STATE OF HAWAII DEPARTMENT OF TRANSPORTATION HIGHWAYS DIVISION
HIGHWAY LIGHTING PLAN
MOANALUA FREEWAY RAMPS RESURFACING
Vicinity of Ala Kapuna to Vicinity of Ala Napunani
Fed. Aid Project No. STP-H20(3)
Scale: 1"=20' Date: June, 1998
SHEET No. E-1 OF 2 SHEETS

STATE OF HAWAII DEPARTMENT OF TRANSPORTATION HIGHWAYS DIVISION	
HIGHWAY LIGHTING DETAILS	
MOANALUA FREEWAY RAMPS RESURFACING	
Vicinity of Ala Kapuna to Vicinity of Ala Napunani	
Fed. Aid Project No. STP-H201-(3)	
Not to Scale	Date: June, 1998
SHEET No. E-2 OF 2 SHEETS

MOANALUA FREEWAY RAMP RESURFACING
Vicinity of Ala Kapuna to
Vicinity of Ala Napunani
Fed. Aid Project No. STP-H201(3)
Scale: 1"=20' Date: Oct., 1998

JUNCTION BOX MOUNTING

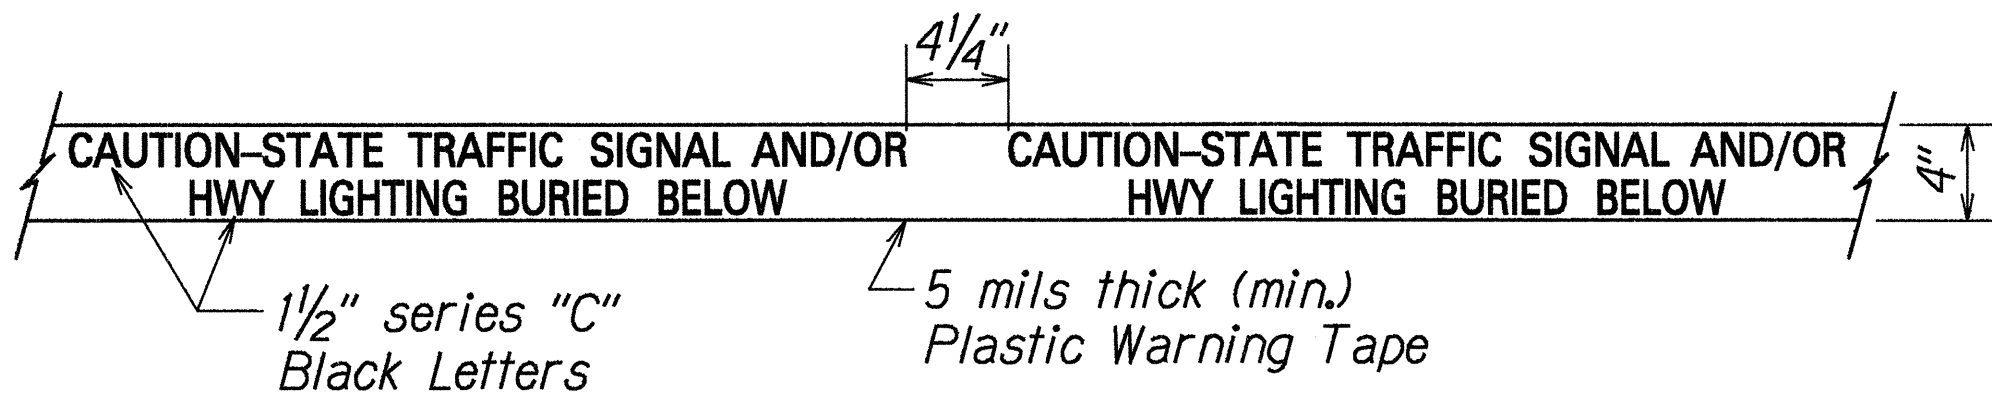
10/5/98	Revised Electrical Plan and Added Junction Box Mounting & Warning Tape Details.
DATE	REVISION

ELECTRICAL PLAN - NEW

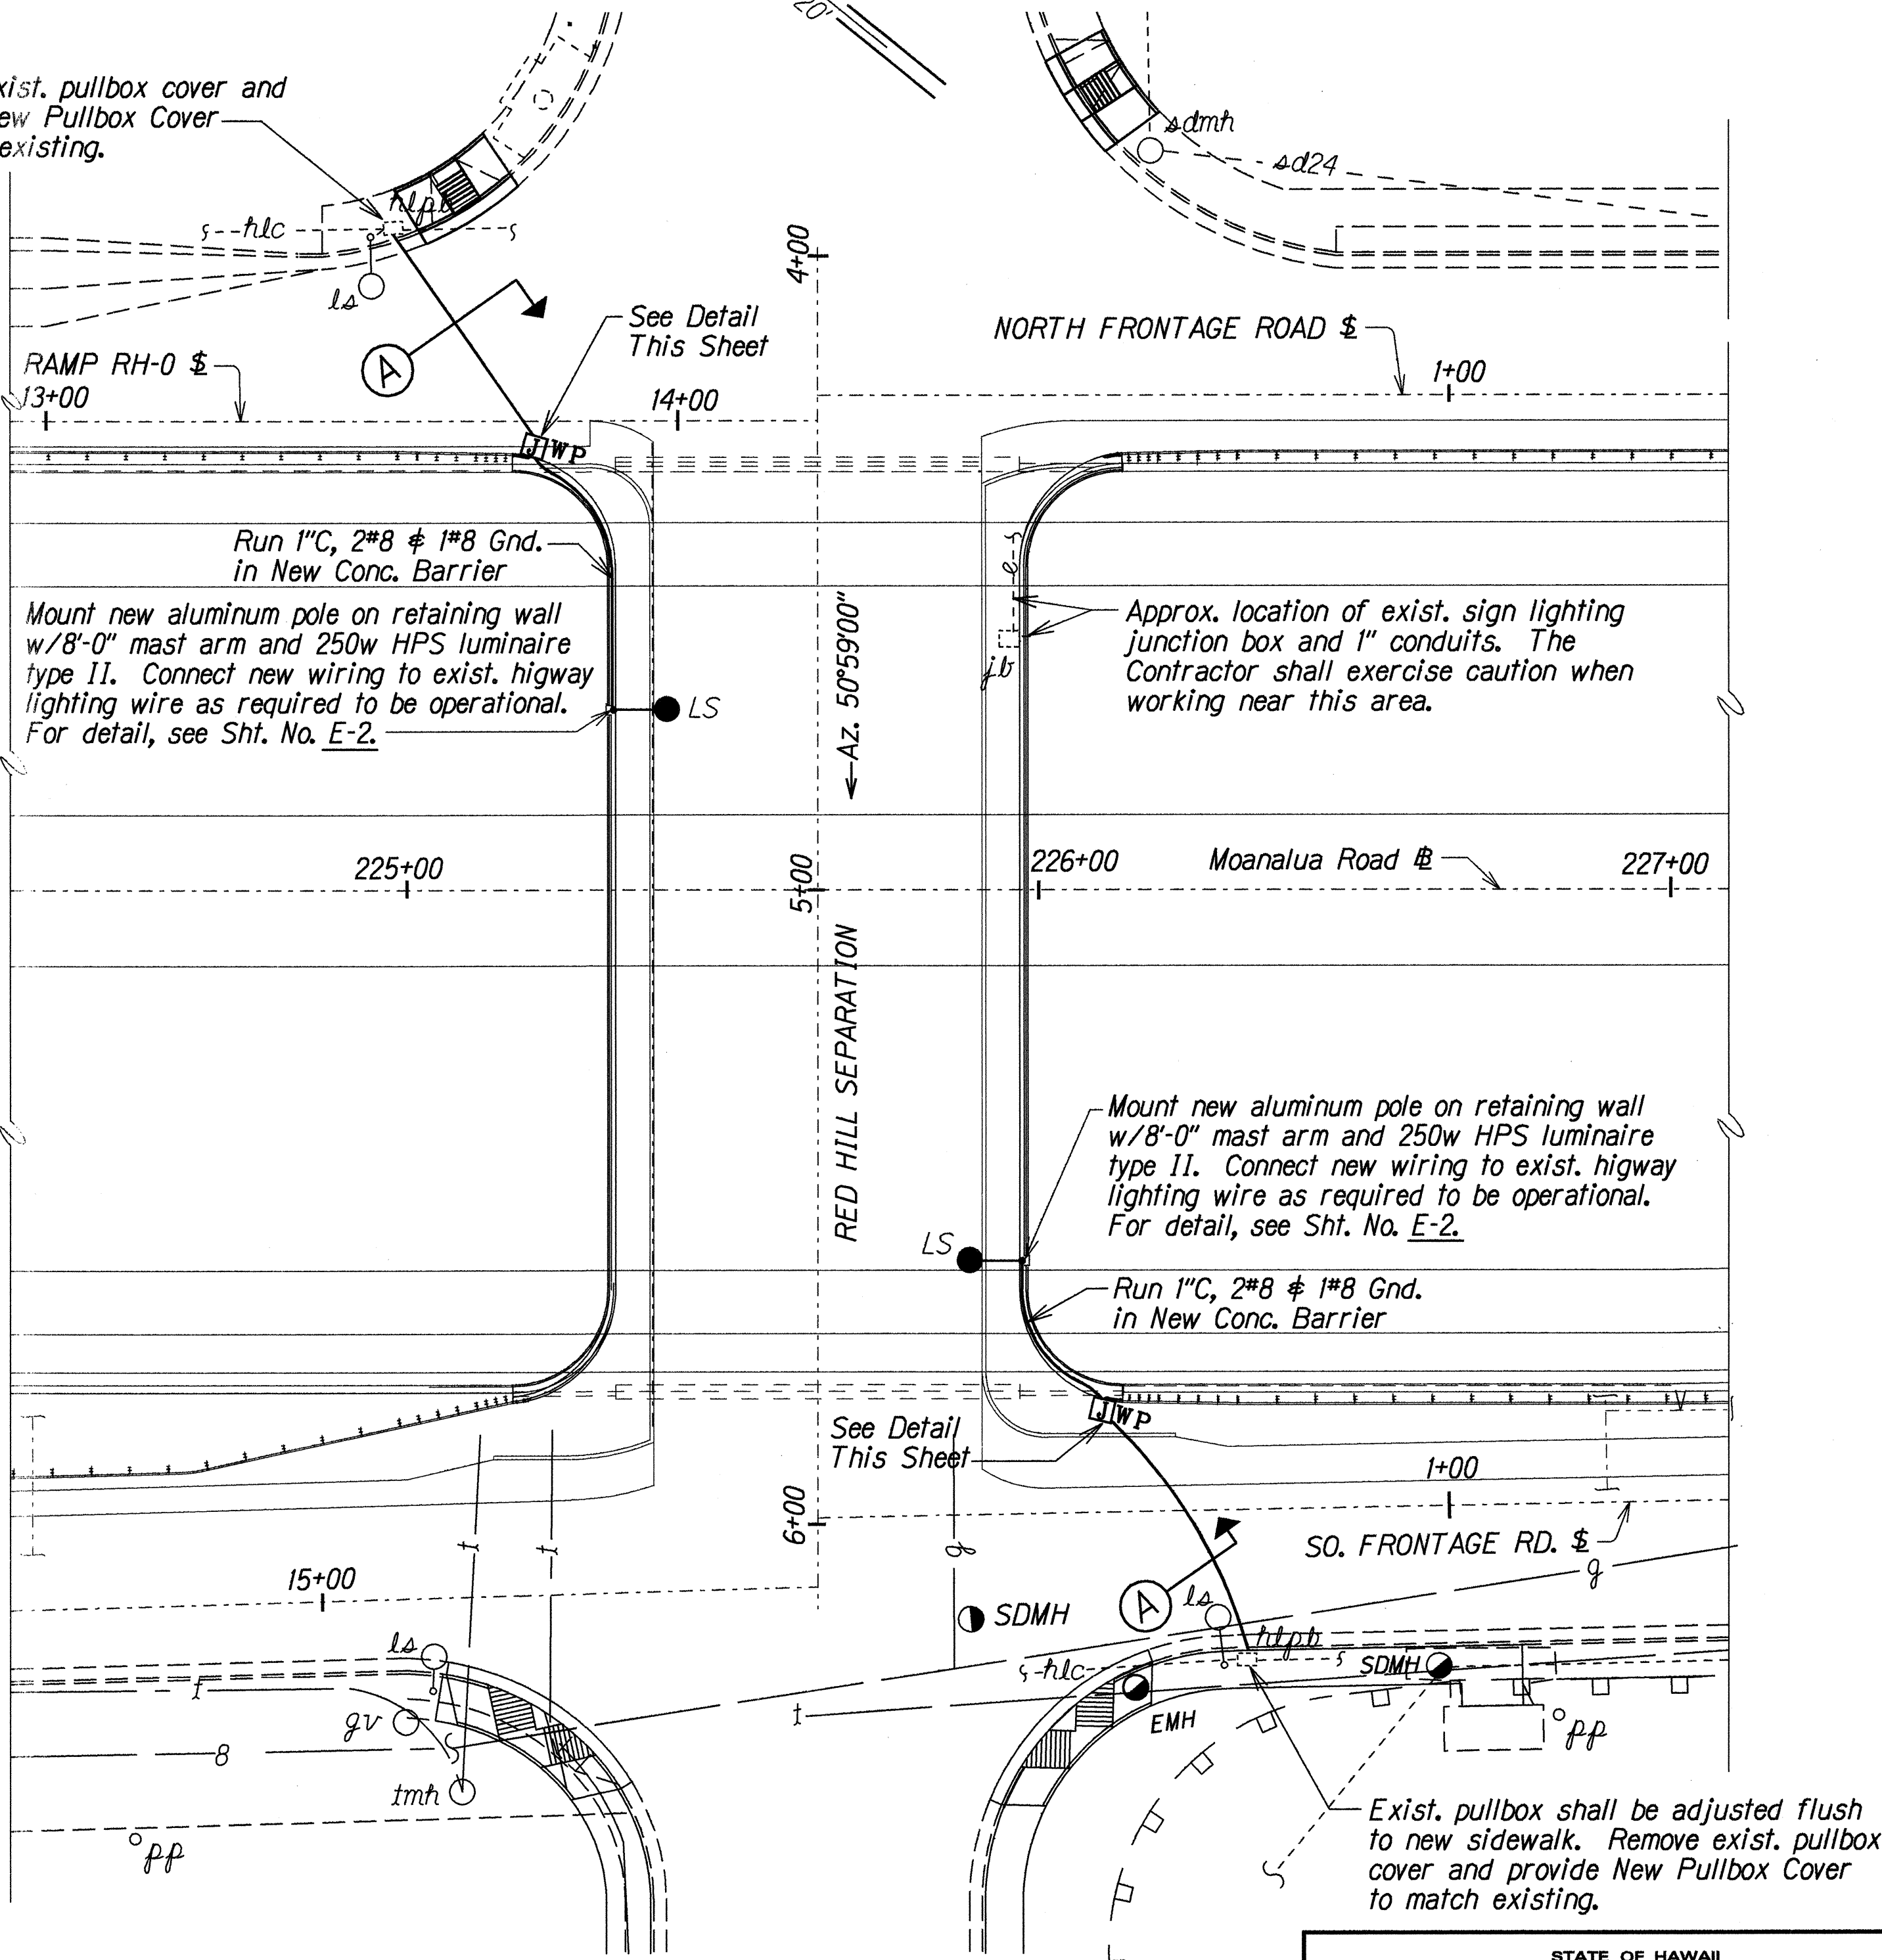
Remove exist. pullbox cover and provide New Pullbox Cover to match existing.

**TYPICAL LIGHT STANDARD
INSTALLATION ON RETAINING WALL**
Not to Scale

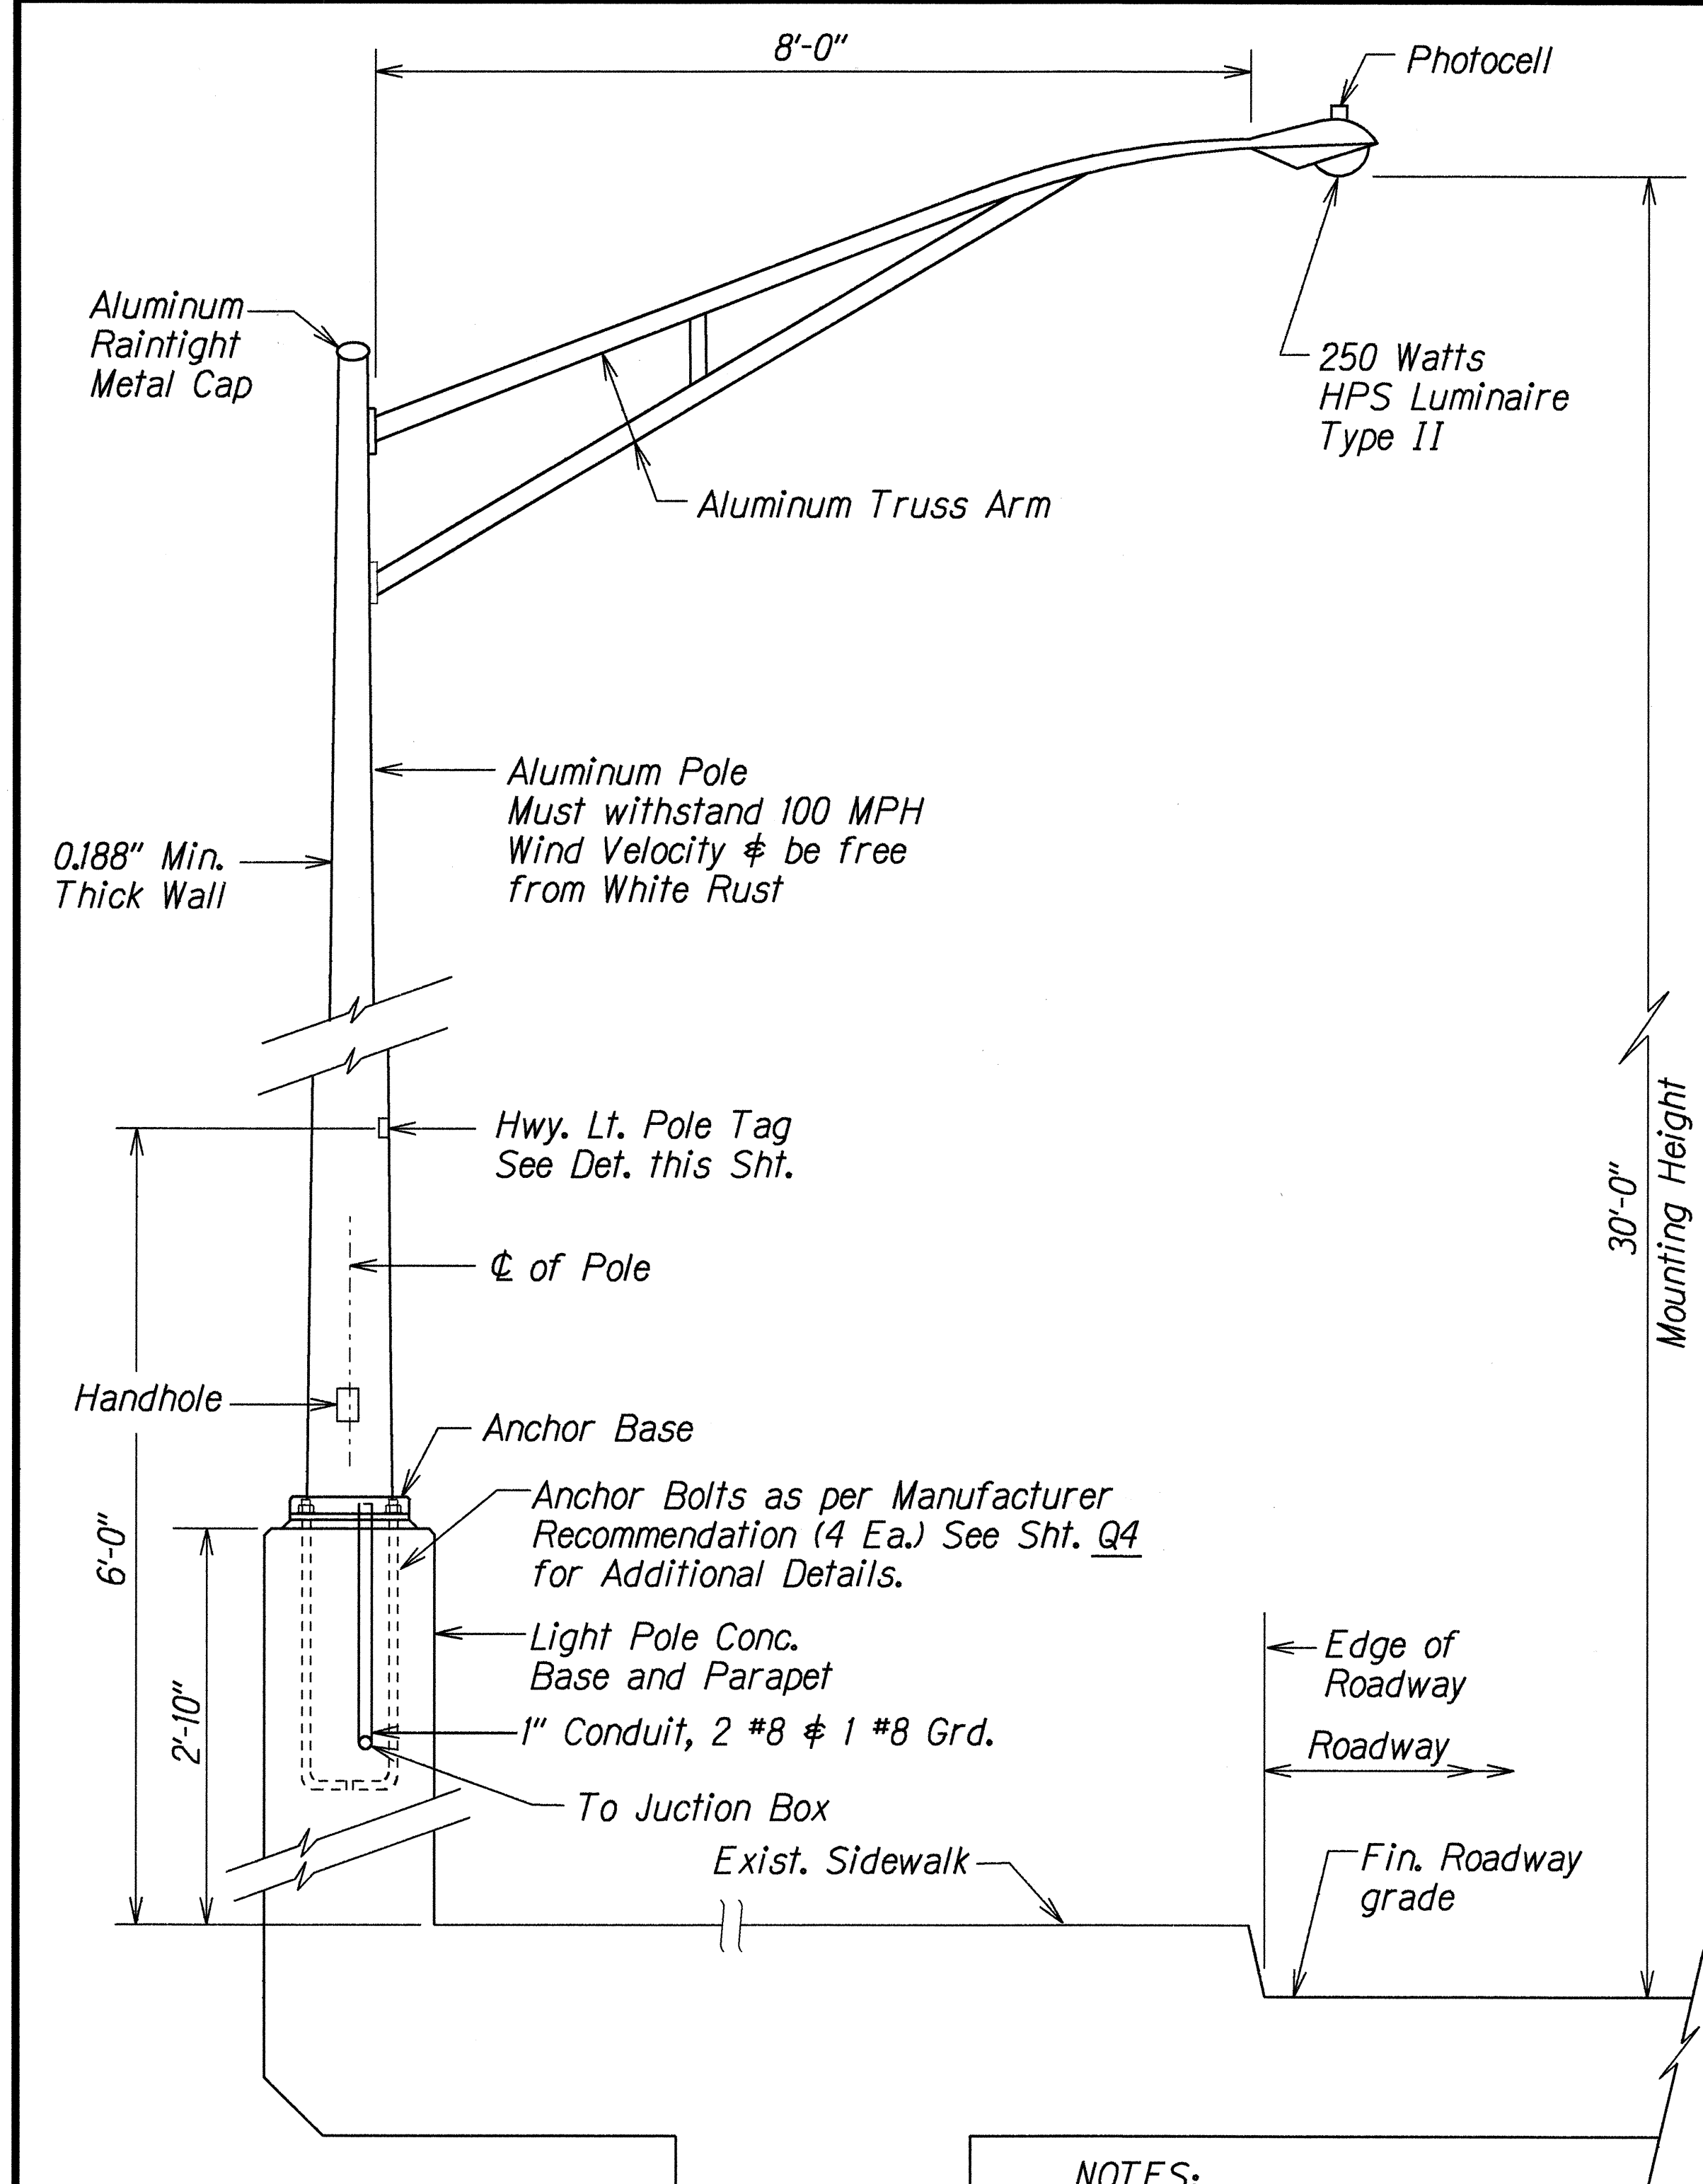
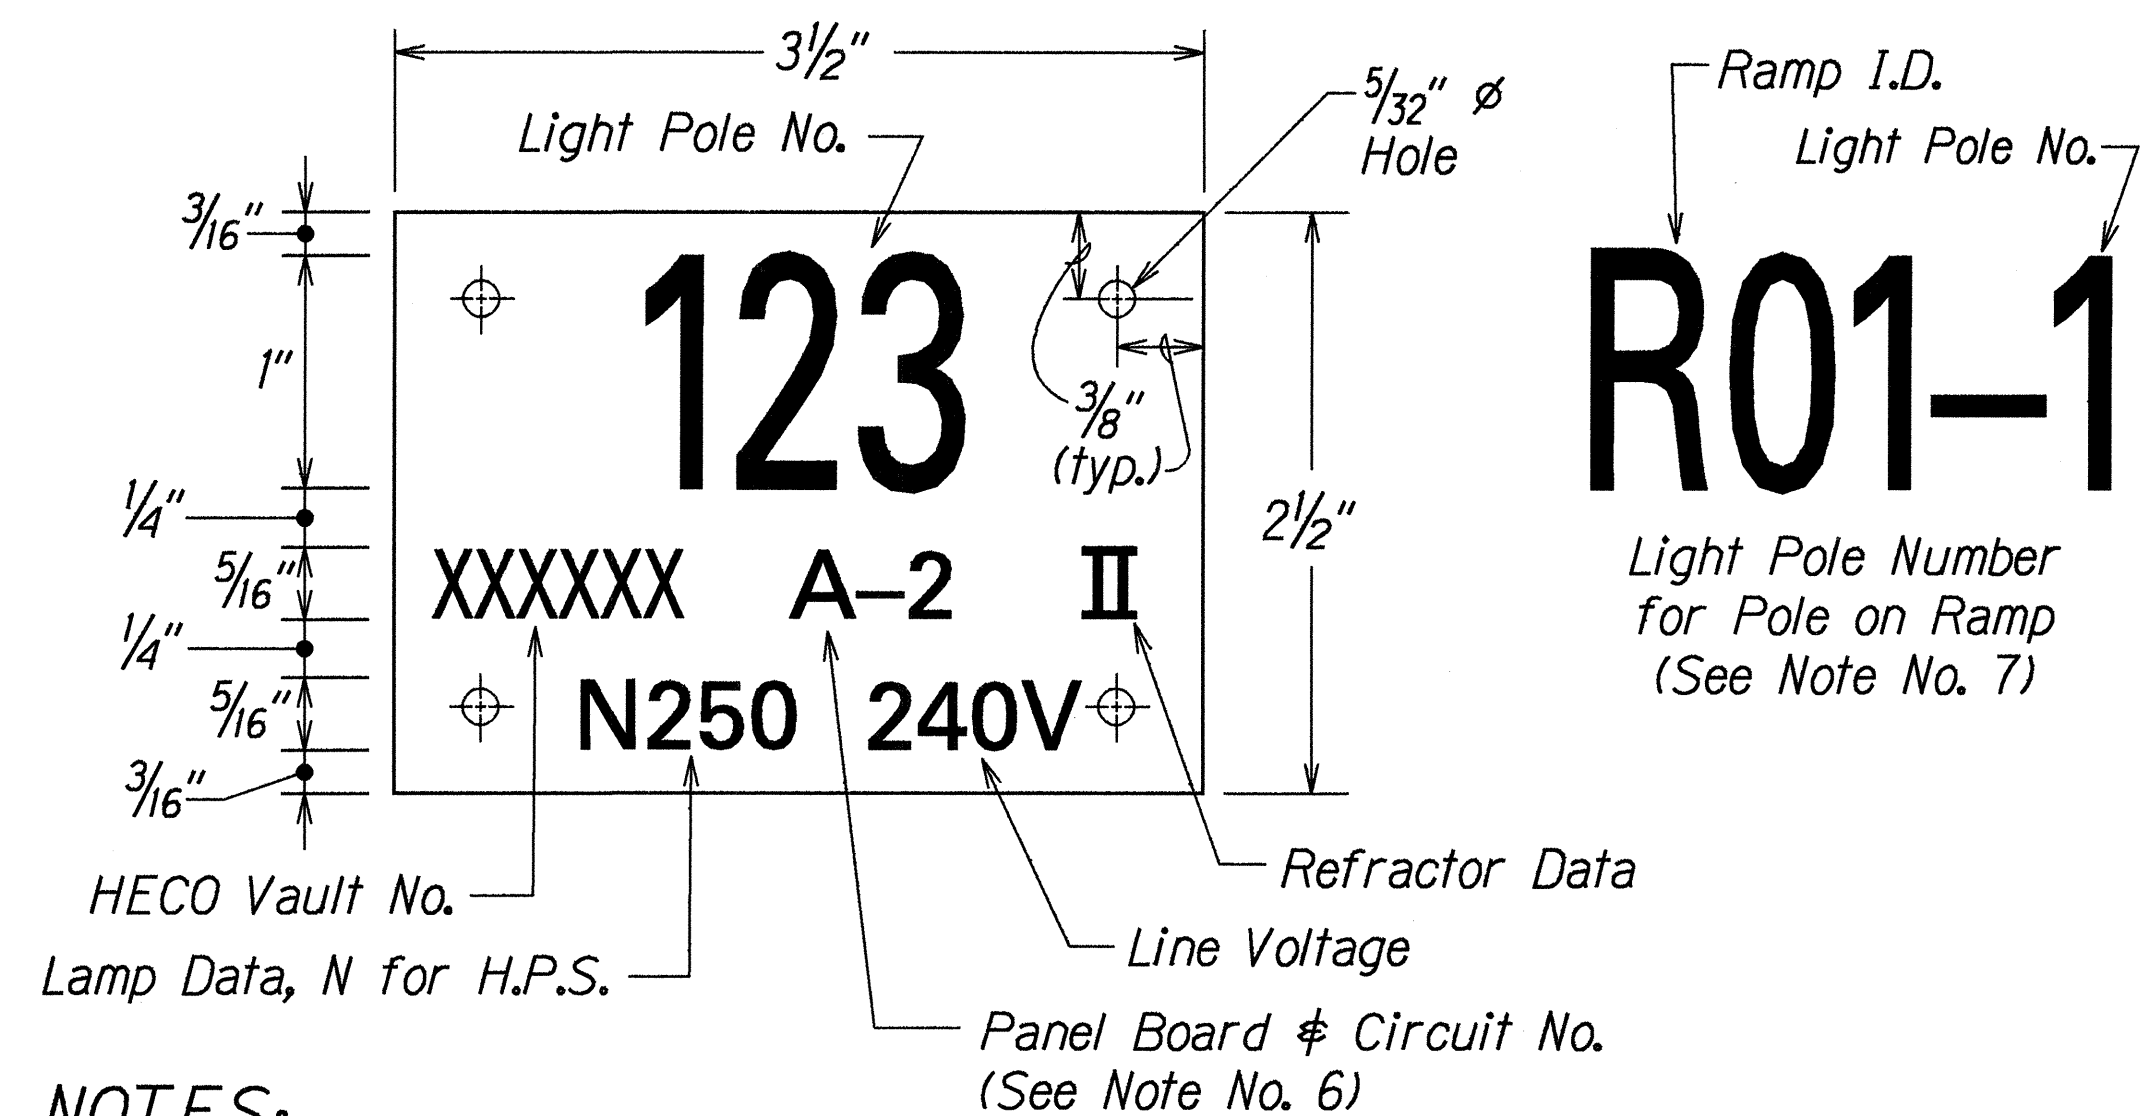
10/5/98	Revised Typical Light Standard Installation on Retaining Wall Detail and Notes.
DATE	REVISION

- NOTES:**
1. Conduit installed in Retaining Wall shall be considered incidental to Highway Lighting Standard Mounted on Retaining Wall.
 2. Conduit from Existing Lighting Pullbox to New Junction Box shall be paid for under Item No. 622.5031 - One 1-Inch PVC Conduit, Schedule 40, Concrete Encased for Highway Lighting System.
 3. All New Wiring and Connections to Existing Highway Lighting System and Junction Boxes shall be considered incidental to Highway Lighting Standard Mounted on Retaining Wall.
